PROJECT  
LIVERPOOL HEALTH & ACADEMIC PRECINCT  
ELIZABETH STREET LIVERPOOL, NSW  
CLIENT  
HEALTH INFRASTRUCTURE  
14/77 PACIFIC HWY, NORTH SYDNEY NSW 2060

STATUS  
SSDA AMENDMENT

Approved Section: 4.55(1A)    Application: 55D-10388-Mod-1

PROJECT NO. 21807 DRAWING NO. A-SSDA-MSCP-12 ISSUE 08 STATUS SSSA AMENDMENT

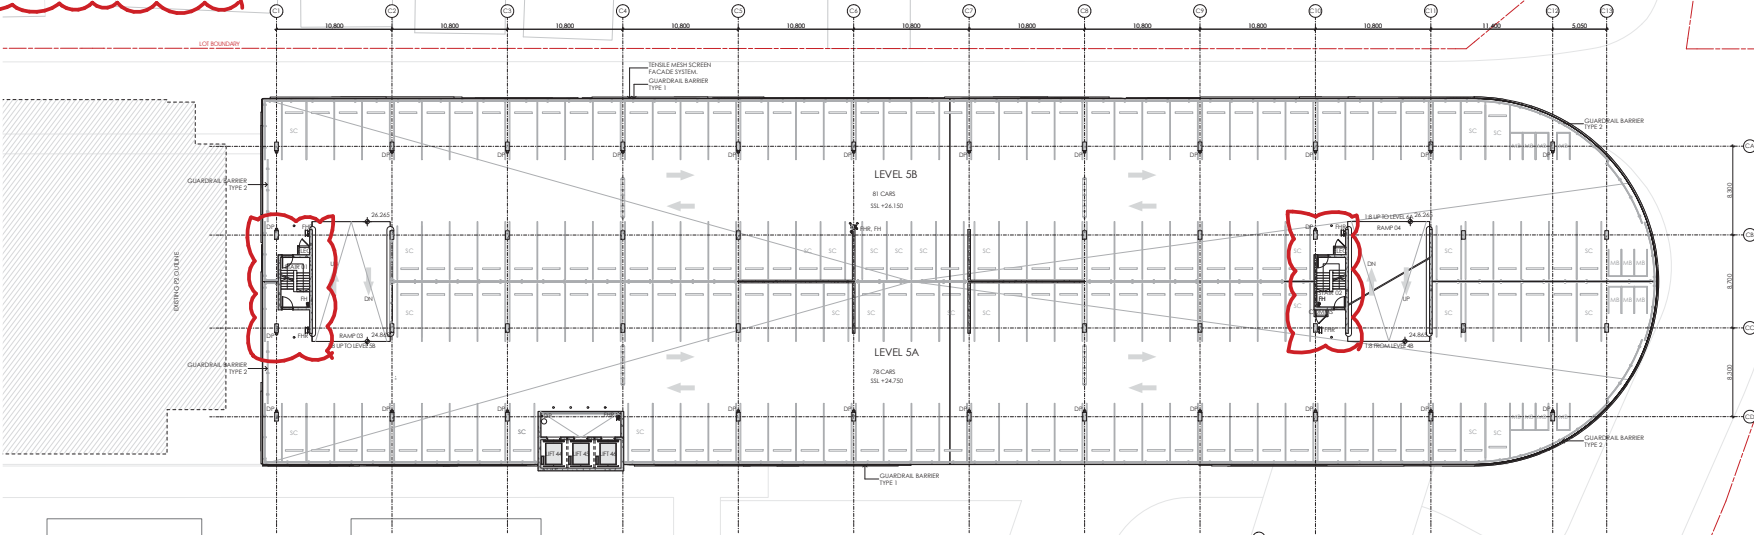
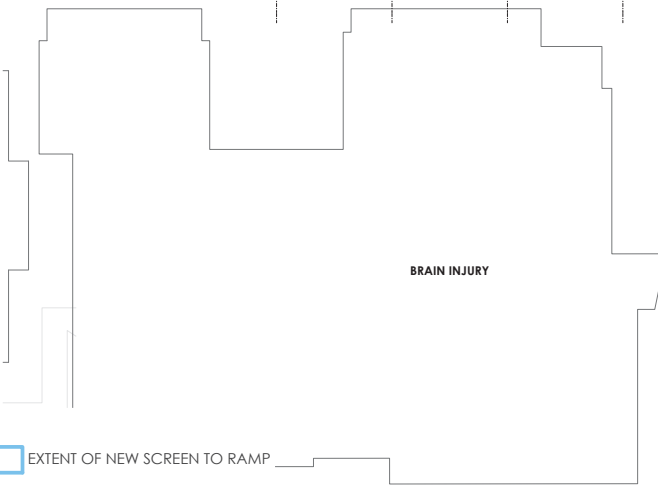
FIRE STAIR (WEST) RELOCATED TO GRID C1/CC ON ALL LEVELS (PREVIOUSLY ADJACENT TO LIFT CORE)

FIRE STAIR (EAST) GRID C10/CC ON ALL LEVELS RECONFIGURED ON ALL LEVELS

PROJECT NO. 21807 DRAWING NO. A-SSDA-MSCP-13 ISSUE 08  
 STATUS SSDA AMENDMENT

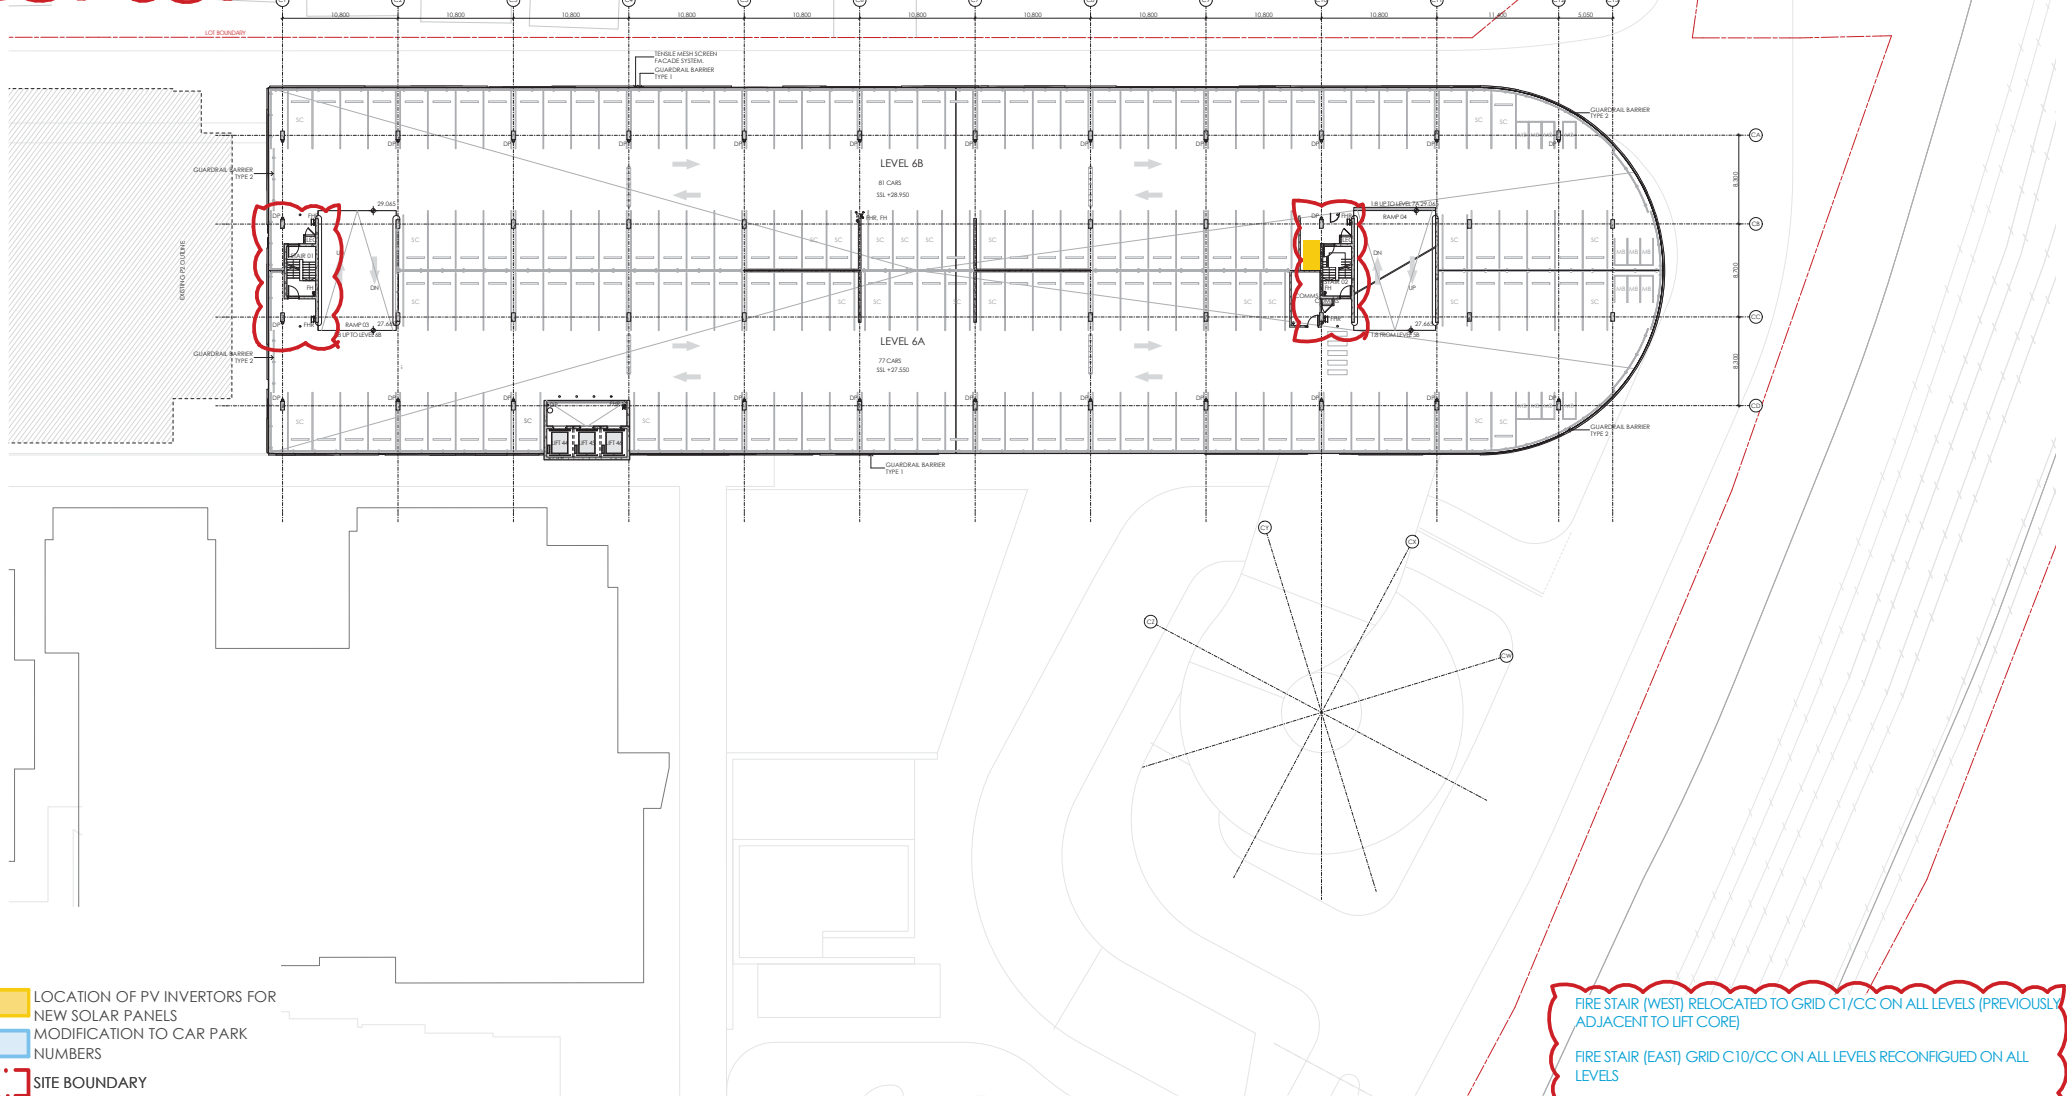
- FIRE STAIR (WEST) RELOCATED TO GRID C1/CC ON ALL LEVELS (PREVIOUSLY ADJACENT TO LIFT CORE)
- FIRE STAIR (EAST) GRID C10/CC ON ALL LEVELS RECONFIGURED ON ALL LEVELS
- REMOVAL OF ONE CAR BAY TO ALLOW FOR NEW SOLAR PANEL ARRAY INVERTORS

PROJECT NO.	DRAWING NO.	ISSUE
21807	A-SSDA-MSCP-14	08
STATUS <b>SSDA AMENDMENT</b>

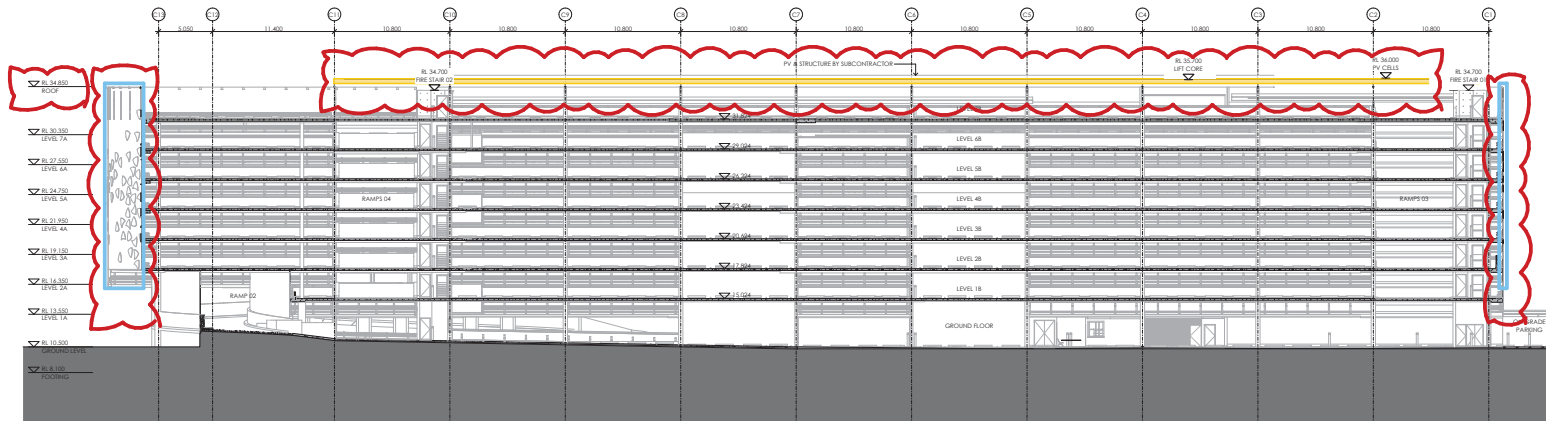
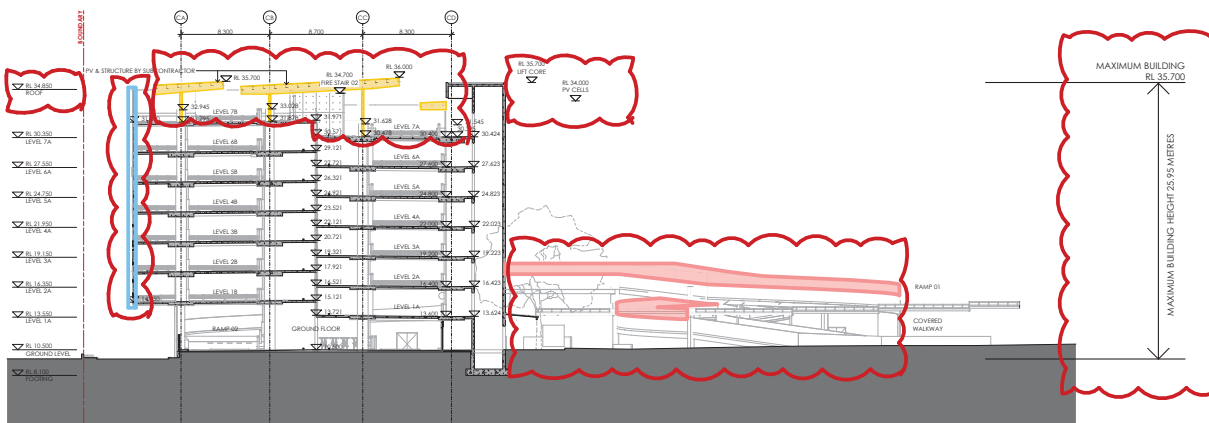
A NEW FAÇADE ARTWORK TO REPLACE THE PREVIOUS FAÇADE DESIGN.  
THE ADDITION OF A PERFORATED METAL SAFETY SCREEN TO THE SPIRAL RAMP.  
ADJUSTMENTS TO THE HEIGHT OF THE FAÇADE

- EXTENT OF NEW FAÇADE ARTWORK
- EXTENT OF NEW SOLAR PANEL ARRAY
- EXTENT OF NEW SAFETY SCREEN TO RAMP

DRAWING NO.  
A-SSDA-MSCP-15

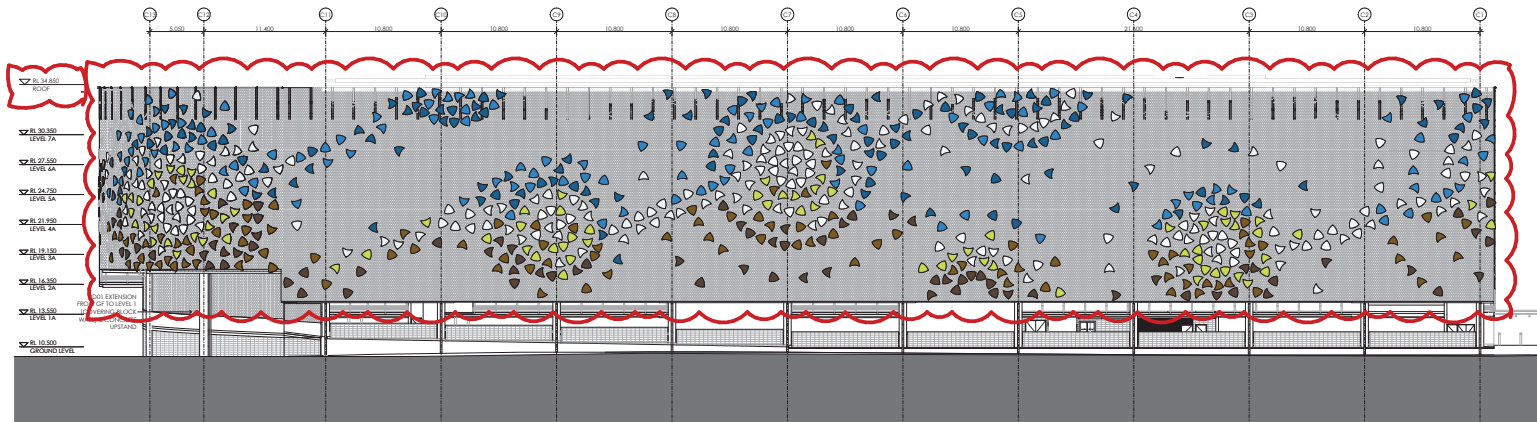
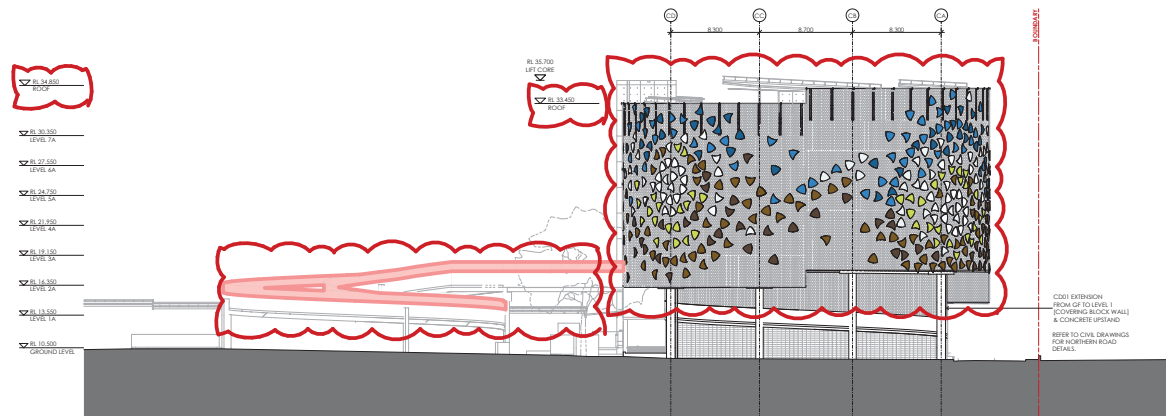
A NEW FAÇADE ARTWORK TO REPLACE THE PREVIOUS FAÇADE DESIGN.

THE ADDITION OF A PERFORATED METAL SAFETY SCREEN TO THE SPIRAL RAMP.

ADJUSTMENTS TO THE HEIGHT OF THE FAÇADE

EXTENT OF NEW SAFETY SCREEN TO RAMP

PROJECT NO.	DRAWING NO.	ISSUE
21807	A-SSDA-MSCP-16	08
STATUS <b>SSDA AMENDMENT</b>

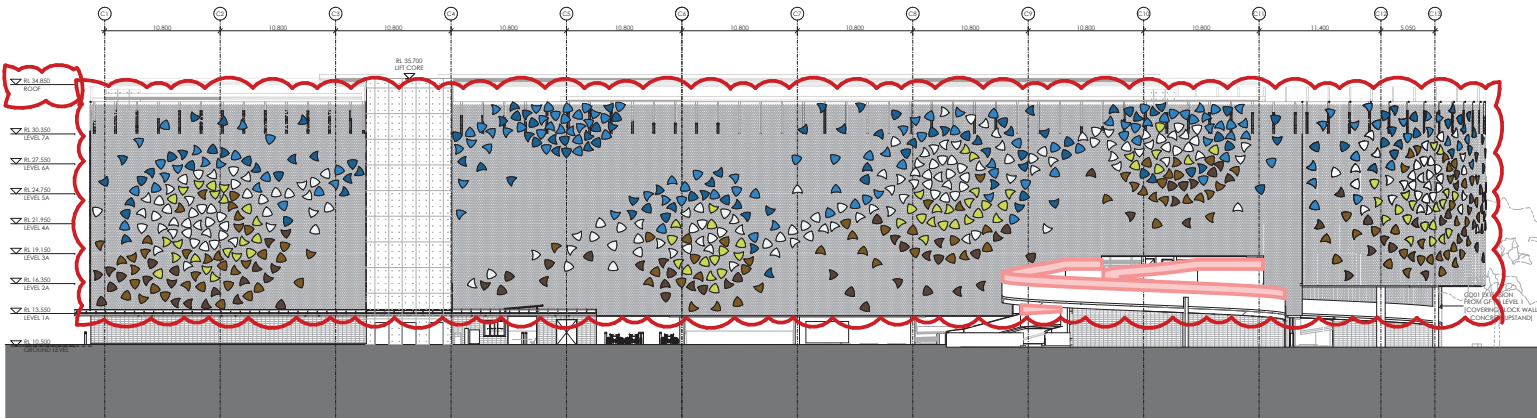
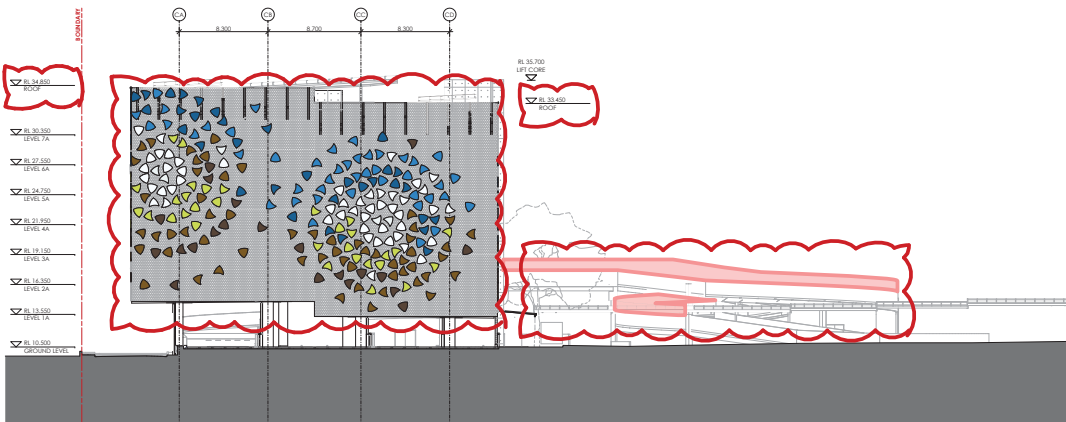
A NEW FAÇADE ARTWORK TO REPLACE THE PREVIOUS FAÇADE DESIGN.

THE ADDITION OF A PERFORATED METAL SAFETY SCREEN TO THE SPIRAL RAMP.

ADJUSTMENTS TO THE HEIGHT OF THE FAÇADE

EXTENT OF NEW SAFETY SCREEN TO RAMP

PROJECT NO.  
21807  
DRAWING NO.  
A-SSDA-MSCP-27  
ISSUE  
08  
STATUS  
SSDA AMENDMENT

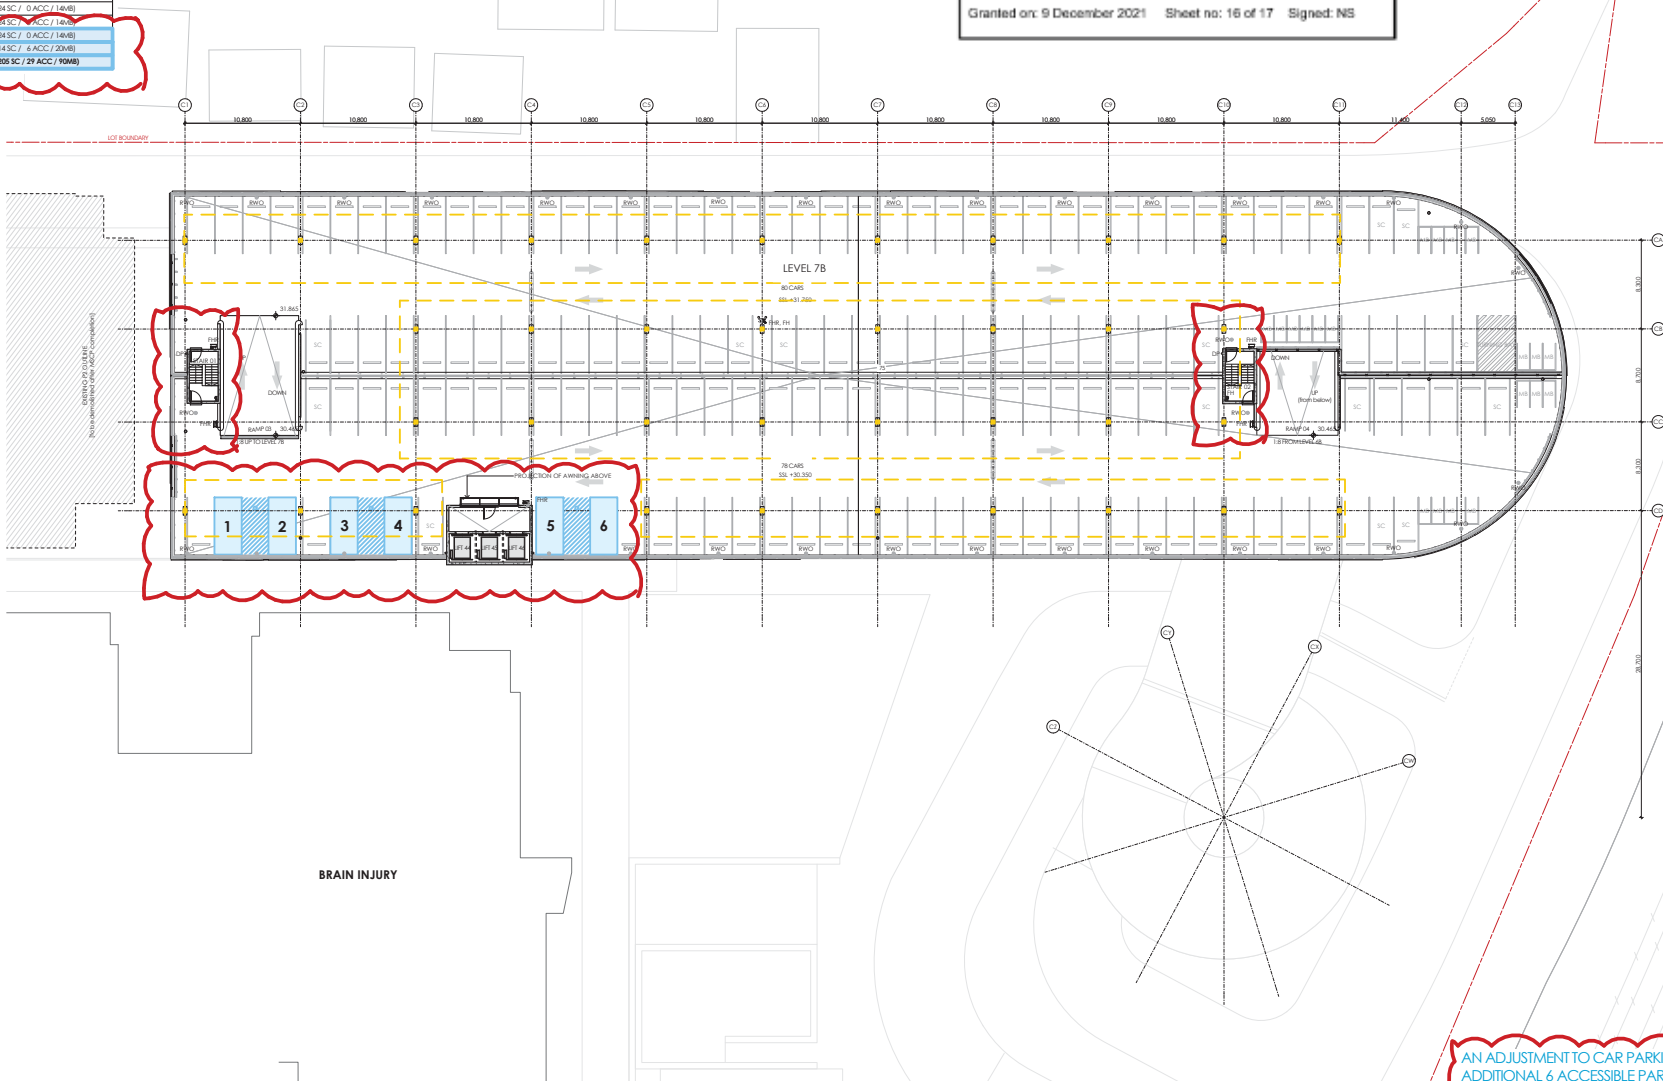
- LOCATION OF STRUCTURE FOR NEW SOLAR PANEL ARRAY
- MODIFICATION TO CAR PARK NUMBERS
- SITE BOUNDARY

AN ADJUSTMENT TO CAR PARKING NUMBERS TO ACCOMMODATE AN ADDITIONAL 6 ACCESSIBLE PARKING BAYS LOCATED ON THE ROOF (RESULTING IN A NET LOSS OF 3 SPACES OVERALL).

FIRE STAIR (WEST) RELOCATED TO GRID C1/CC ON ALL LEVELS (PREVIOUSLY ADJACENT TO LIFT CORE)

FIRE STAIR (EAST) GRID C10/CC ON ALL LEVELS RECONFIGURED ON ALL LEVELS
